July 18, 2017 GH17563-G

Subject: Response to City of Los Angeles Review Letter, Proposed Private Street

1437 for Access to 1830 N. Blue Heights Drive; PT NE 1/4 Sec 7, T1S,

R14W (Arb 23); 1830 N. Blue Heights Drive, Los Angeles, California.

## **GEOLOGIC MAP 1**

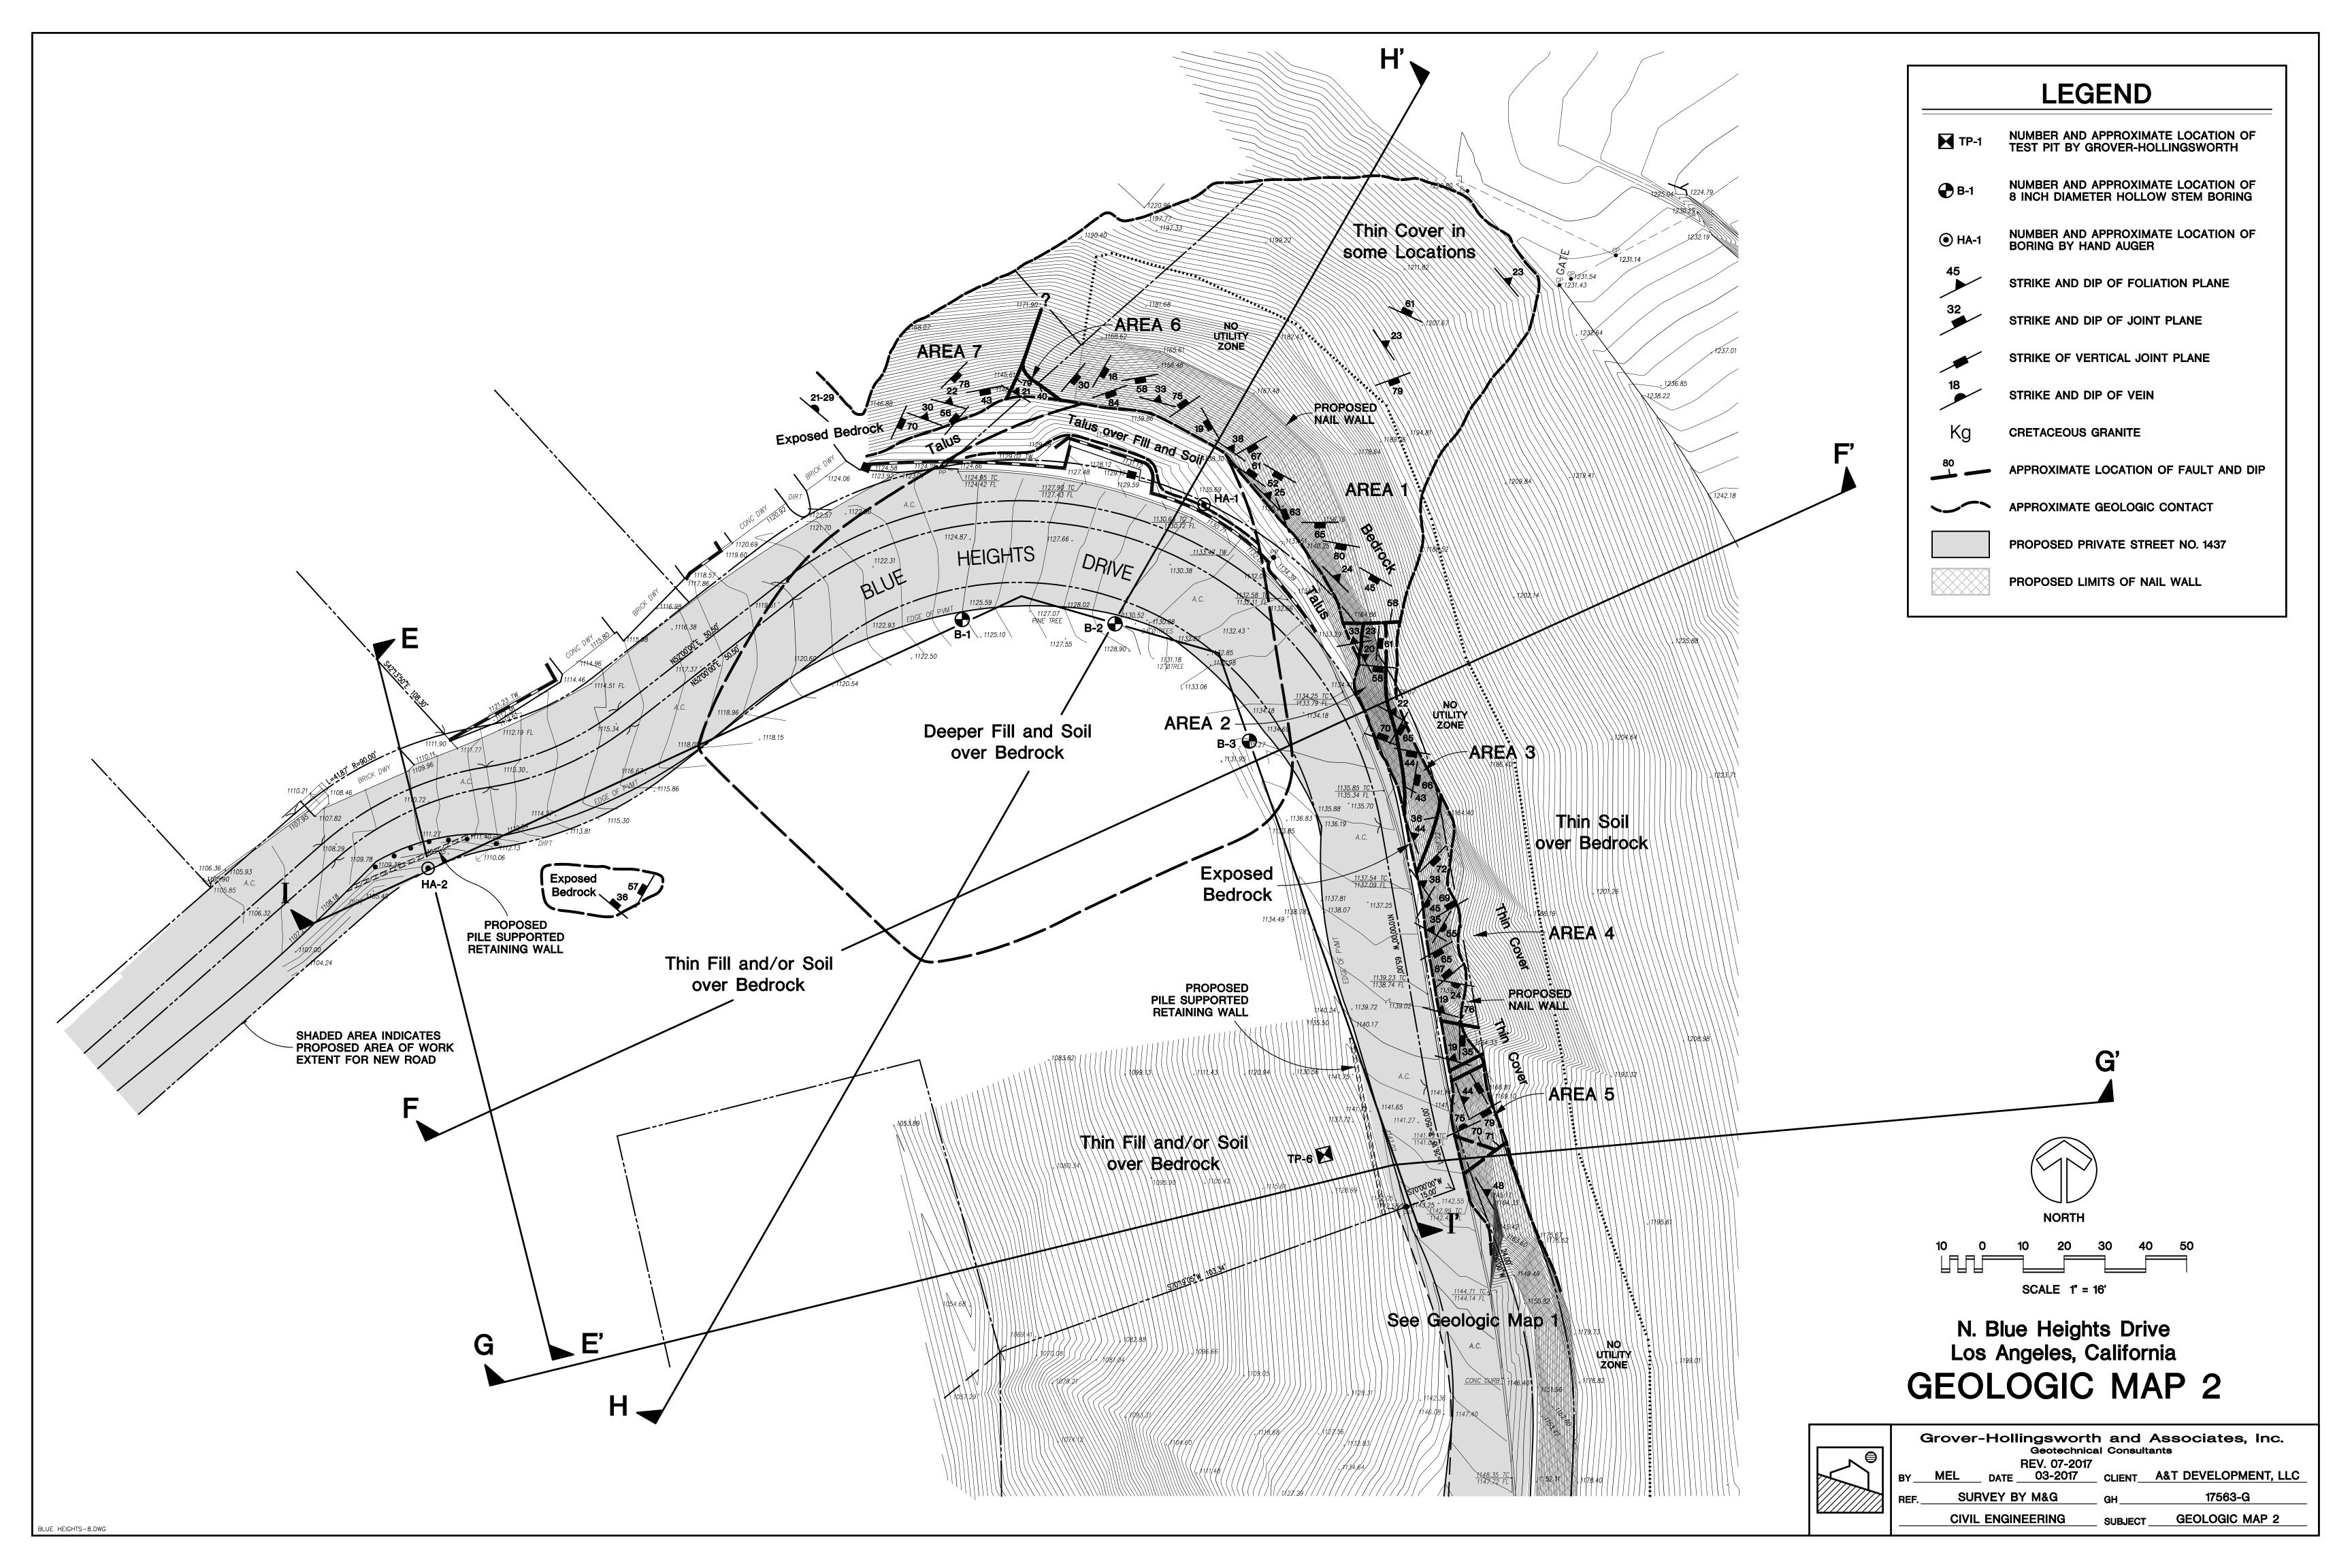
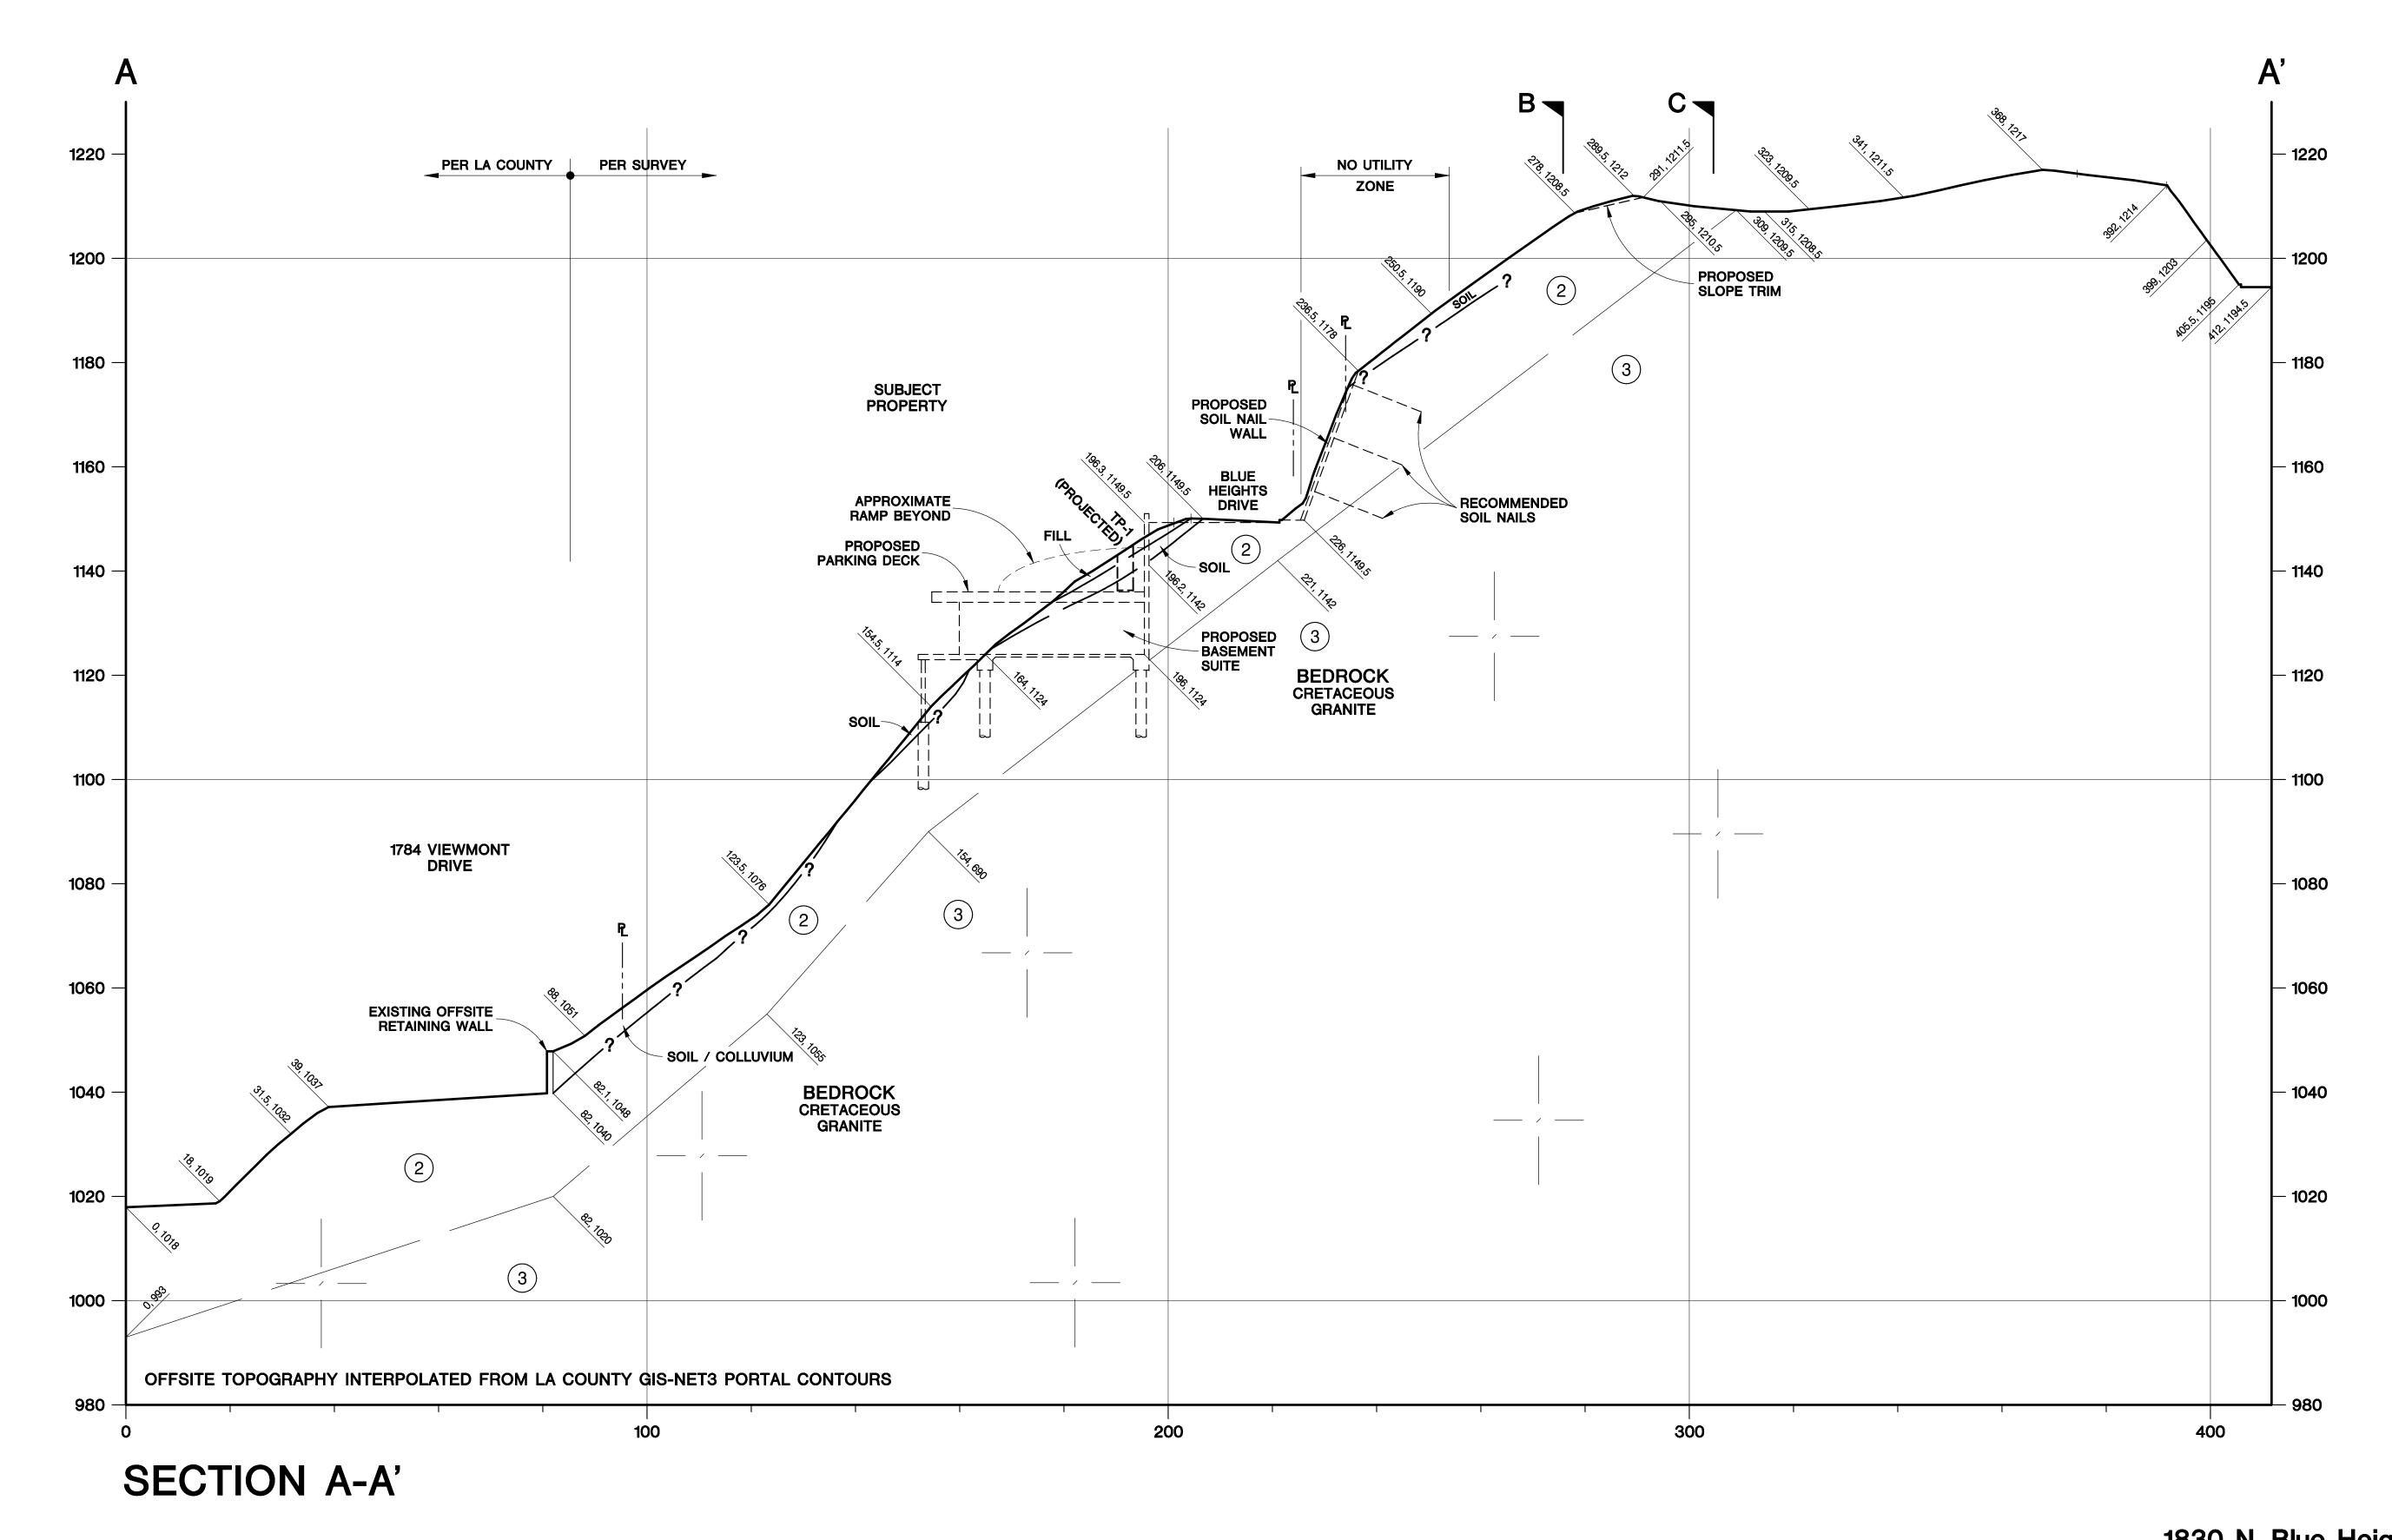
*Item 1:* Revise the Geotechnical Map(s) to show the proposed soil nail wall. The Geotechnical Map(s) shall be based on the updated Private Street Map.

**Item 6:** Provide a geologic map and cross section/s showing the location of the proposed soil nail retaining system. Specify the length of the soil nails on the geologic cross-section(s) and show drainage behind the soil nail wall.

**Item 9:** Depict on the geologic map inclinometer location(s) and any areas where not future utility lines/excavations will be recommended without prior soil engineering approval.

**Response:** As discussed above, the geologic maps have been revised to reflect the planned soil nail wall.

**Response:** The geologic maps and applicable cross sections have been revised to show the location of the soil nail facing. The soil nail lengths and spacing on the sections are in conformance with the analyses provided in our referenced report. The necessity to show drainage on the sections was discussed in our meeting and it was determined that the drainage discussion in the referenced report is sufficient.

**Response:** Utilities should not be placed under the soil nail wall or in the area titled "No Utility Zone" on the enclosed geologic maps.
